CITY OF SEASIDE
BOARD OF ARCHITECTURAL REVIEW

**CITY OF SEASIDE
STAFF REPORT**

SUBJECT: **BOARD OF ARCHITECTURAL REVIEW APPLICATION NO. BAR-18-08. GREGORY MEUERS AND LIZETTTE BOYER, PROPERTY OWNERS, AND AARON TOLLEFSON, APPLICANT, ARE REQUESTING DESIGN APPROVAL FOR A SECOND STORY ADDITION TO AN EXISTING TWO-STORY SINGLE-FAMILY RESIDENCE LOCATED AT 1536 NOCHE BUENA STREET IN THE SINGLE FAMILY RESIDENTIAL (RS-12) ZONING DISTRICT (APN: 012-201-012). THIS PROJECT IS CATEGORICALLY EXEMPT CLASS 1, SECTION 15301.E.1, EXISTING FACILITIES, FROM THE CALIFORNIA ENVIRONMENTAL QUALITY ACT**

NEW ADDITION FOR MEUERS-BOYER RESIDENCE

View of dwelling from 1540 Kenneth Street with roof line and walls of former design superimposed

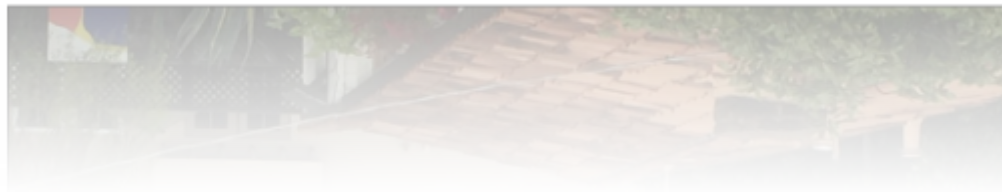
Staff has received a comment letter from the neighbor at 1540 Kenneth Street indicating that they would prefer the exterior walls to be completely framed with windows to preserve views that she now enjoys of the Monterey Bay. Comment letter is provided as Attachment 6. Additional verbal comment was received from property owner at 1537 Lowell Street indicating that the revised project will continue to block some of the view there property has toward the Monterey Bay.

A photo showing the view of the Monterey Bay from 1540 Kenneth Street is provided as Attachment 7. The exhibit contains two images that have been marked up to show how the addition would have looked like with the original hip roof design and how the addition now looks like with a flat roof design. Per the representation of plans using the ridge of the existing trellis as the new roof line, City staff finds that the revised project

We are however disappointed that the original designs that were discussed via email directed us to a revised exterior that would be a glass sunroom design and not a stucco structure which block the natural sunlight.

will preserve views of the Monterey Bay while allowing for a continuity of design in compliance with the Zoning Code and the Single Family Residential Design Guidelines.
